**Sutton Planning Board
Approval Not Required Checklist**

Location: 77-81 Purgatory

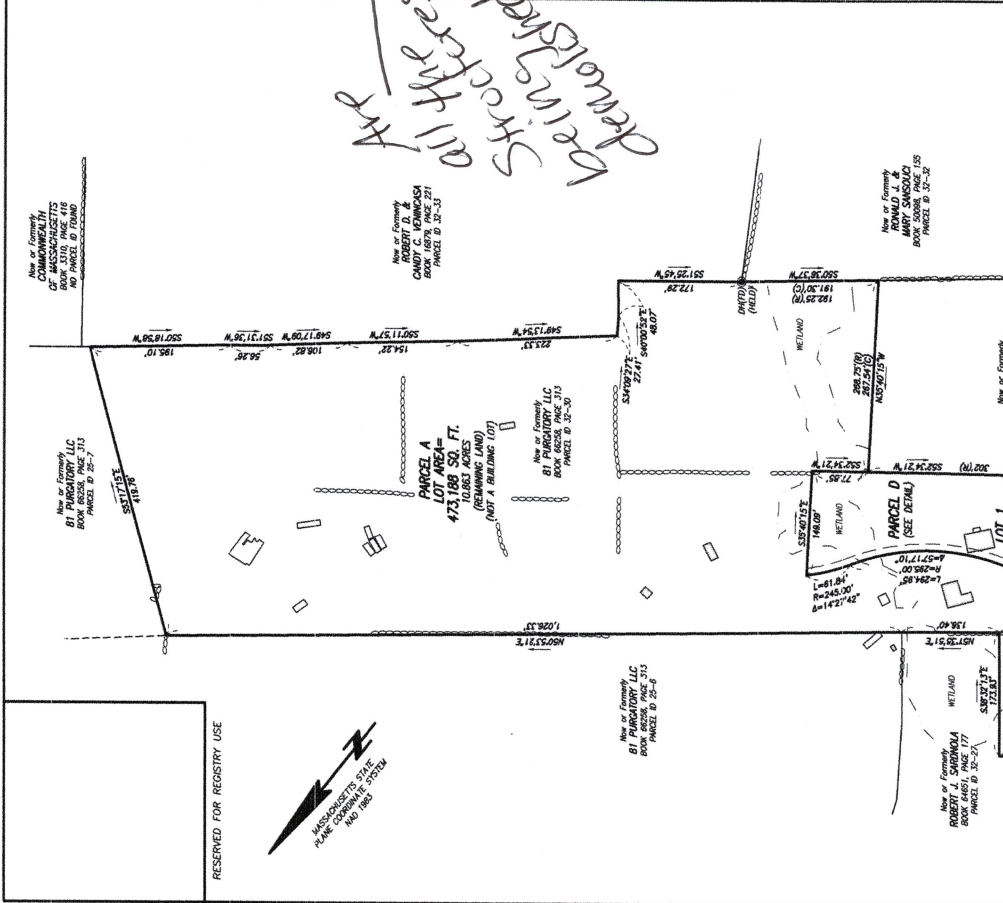
other than the W&HB I don't see any pins/monuments set.

cluttered plan can't clearly determine length of frontage on Purgatory Road see att. plan

★ Structures - Are these to be demolished? You can't create lots that create a non-conformance (building in setback) or non-buildable lots w/ buildings that are or could be inhabited.
